BULLETIN NUMBER:
SB19-J-001

OIL IN THE AIR CLEANER – UPDATED AIR INTAKE DUCT (SERVICE PART)

- 2011-2019MY Isuzu N-Series Vehicles Produced prior to May 28, 2018
Equipped with 5.2L (4HK1) Diesel Engines

Figure 3

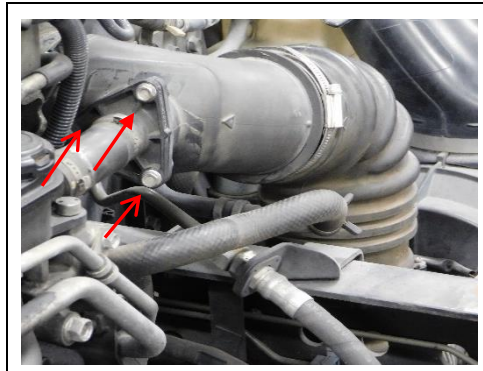
1. Remove three (3) 10mm bolts from the PCV flange pipe and loosen the PCV flange from inlet pipe. (See Figure 3.)

Figure 4 – New clamp location

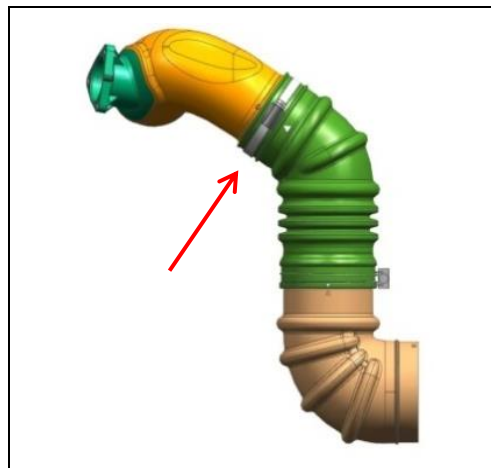
2. Loosen the air duct clamp at the air filter housing (using a 10mm socket).
3. Loosen the air duct clamp at the turbo charger (using a 7mm socket).
4. Remove the air duct as an assembly while also removing the PCV flange from the inlet pipe.
5. Assemble the new duct using the new inlet pipe, new connector hose, and new clamp (see Figure 4) and torque clamp to 6.4 N·m (57 lb·in). Transfer air filter housing clamp to the updated air duct.

Figure 11

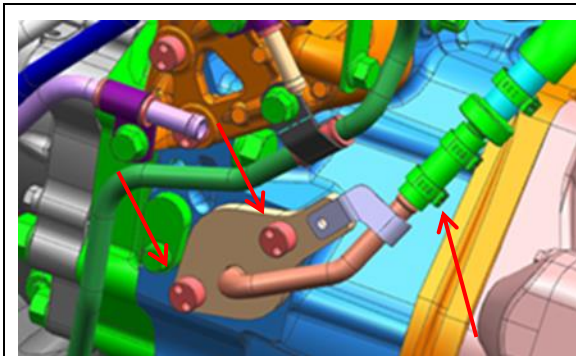
12. Using a flat blade screwdriver remove the lower clip (Oetiker clamp) from the PCV drain hose and disconnect the hose. (See Figure 11.)
13. Remove the two (2) tamper proof bolts (Figure 11) from drain plate using Special Tool EN-48711. (See Figure 12.)
14. Remove old drain plate. (See Figure 11.)
